SUBJECT: DELUGE, PRE-ACTION AND FOAM-WATER DELUGE SPRINKLER
SYSTEMS: MODEL C DELUGE VALVES

DELUGE, PRE-ACTION AND FOAM-WATER DELUGE SPRINKLER SYSTEMS

MODEL C DELUGE VALVES

PARTS LIST FOR SUPERVISORY AIR SYSTEMS

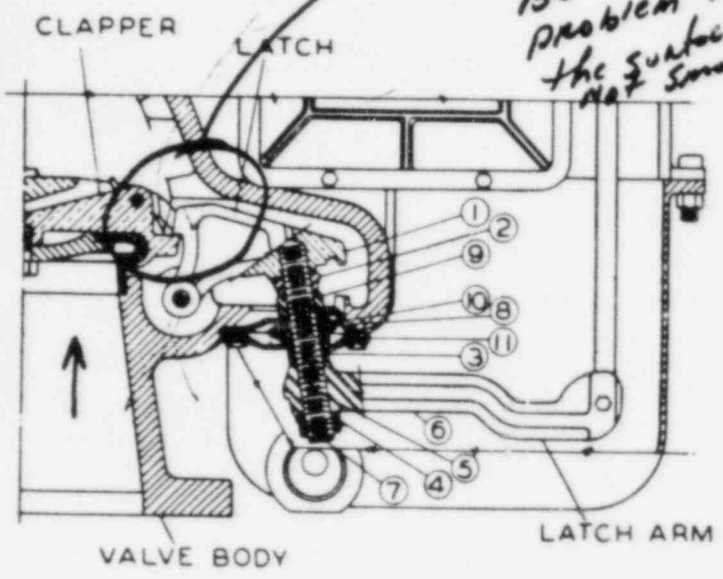
Press
THIS MATING SURFACE APPEARS TO BE A POTENTIAL PROBLEM IF THE SURFACE IS NOT SMOOTH

AT GRAND GULF THE HAD SYSTEM WAS ELECTRIC

MODEL C VALVE

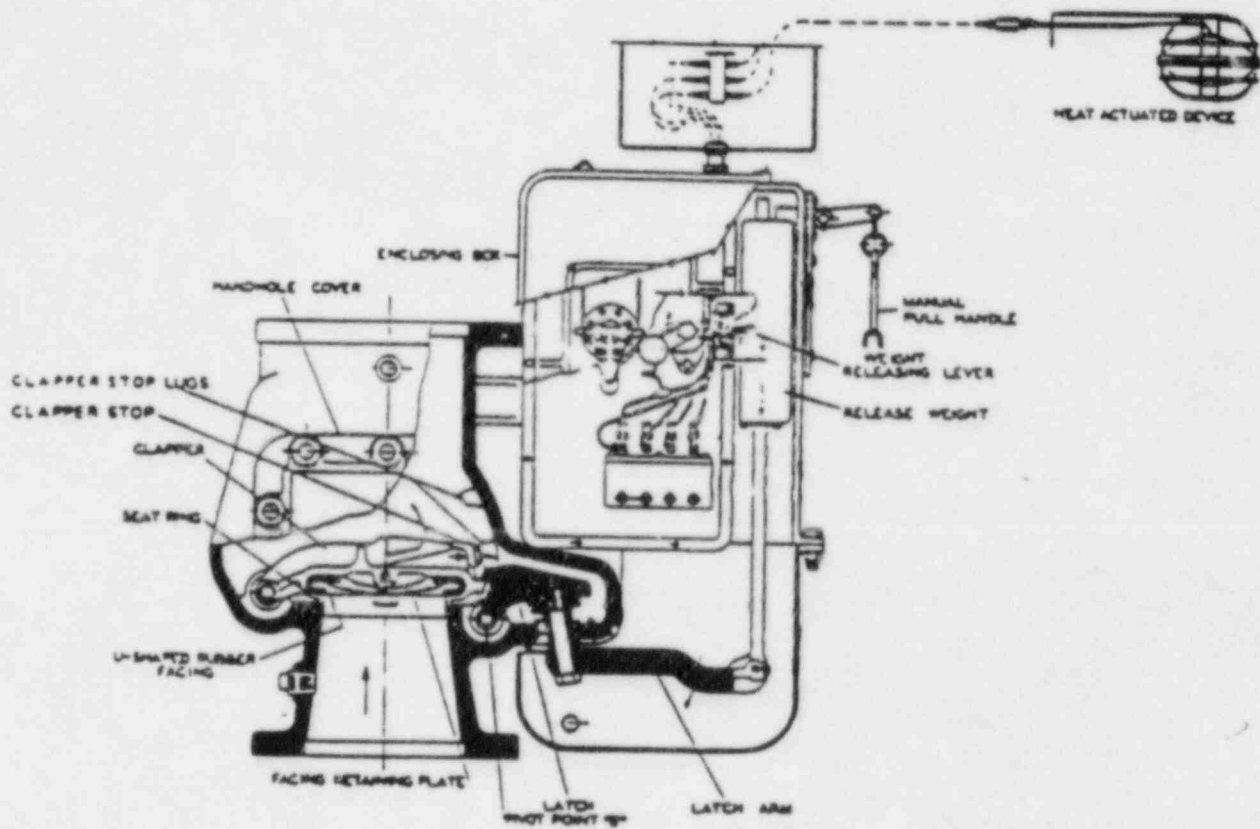
MP&L has sanded and trued the guide rod; reworked the ID of the weight's upper guide collar; lubricated the rod, latch pin, clapper hinge pin, and the enclosed box along the path of the weight guide bushings; temporarily increased the testing frequency of the valves; and revised the surveillance procedures to visually verify that the clapper has lifted and locked open following the test under normal system pressure.
